Landscape Referral Response

Application Number:	DA2025/0163
Date:	21/05/2025
Proposed Development:	Demolition works and construction of a parking platform and carport
Responsible Officer:	Anaiis Sarkissian
Land to be developed (Address):	Lot 22 DP 18005 , 81 Riverview Road AVALON BEACH NSW 2107

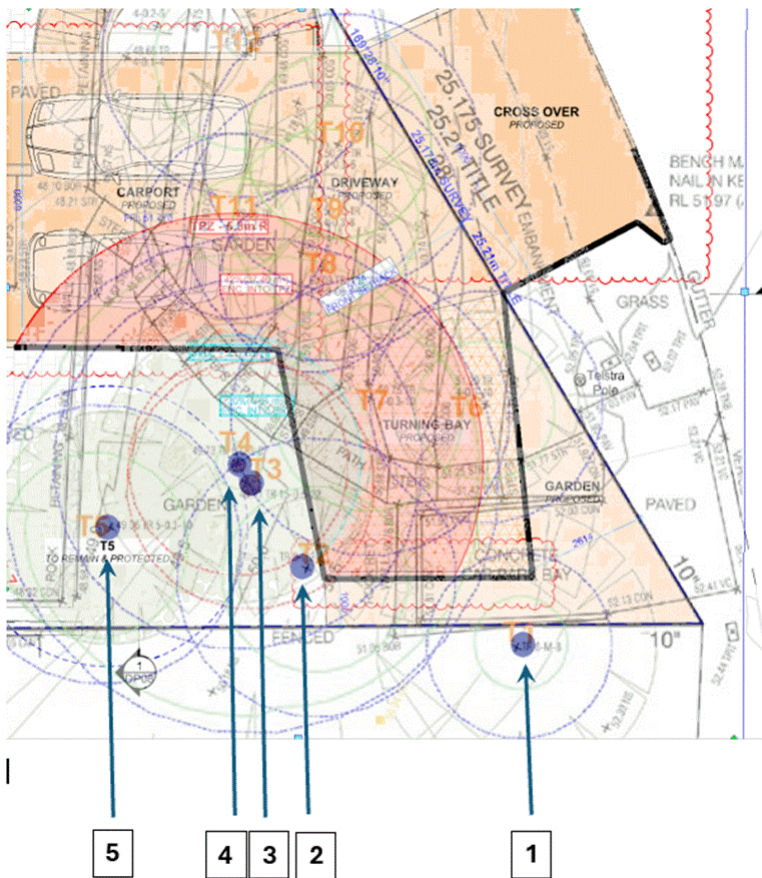
Amended plans are noted indicating of a reduction of size of the parking and turning area and offset from the southern boundary. No amended Arborist Report was noted to be provided.

However, assessment of the amended plans (overlay with Survey below) concludes that Trees 4 (*Allocasuarina torulosa*) and 3 (*Corymbia maculata*) could now be retained, in addition to Trees 1 (*Strelitzia* on neighbour's property) and 5 (*Livistona australis*). Tree 2 is an exempt palm. (Tree locations indicated on the amended plan extract below).

On the amended plans, Tree 3 is indicated to be removed as works overhang the SRZ and Tree 4 is not marked, assuming removal.

An overlay of the indicative pier location and the SRZ (copy below) of T3 (which is close to the same as T4) indicates that all but one of the piers would be outside the SRZ. As structural engineering has not yet been undertaken, design of beam sizes and pier locations could be adjusted to suit the trees following collaboration between a structural engineer and qualified arborist. This can be conditioned.
